# **Request for Further Information and Affected Party Approval**

I have reviewed your Notice of Requirement **D190064**D190064 to extend the designation for Kirwee reserve. More information is needed so that I can better understand your proposal and its potential effects. The written approval of affected parties is also required, in order to process your application on a non-notified basis.

# RESPONSE TO FUTHER INFORMATION: TRANSPORT KIRWEE RESERVE DESIGNATION

Re: Kirwee Recreation Reserve, Kirwee Response to RFI

Figure 2: Manoeuvring for a Tour Coach

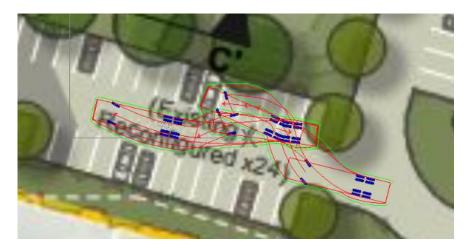
- 6. Please provide a swept path to show how coaches could be accommodated without needing to reverse manoeuvre, and show how many parking spaces would be lost;

- 12. It will be recommended to the clubs that the area highlighted in the figure below is appropriate for coach parking (to be coned off) which will occupy six car parks. Coach parking is arranged / managed by the clubs and some flexibility is required. It is noted

- that coach parking is an existing occurrence and has been managed well to date by the clubs. It is also noted that this level of detail is not proposed to be shown on the Master Plan.
- 13. The location shown below would not result in buses reversing into or across aisles, although it is noted that doing so (if other locations were used) is not considered to be inherently dangerous. The District Plan would allow all vehicles to reverse out of a parking or loading space and buses are both large (visually obvious) and have reverse warning signals (beepers), the drivers must be appropriately licenced to drive a bus and they would also be completing the manoeuvre at very slow speed.

14. The manoeuvring to this area for a NZ Tour Coach (12.6m long) is shown below.
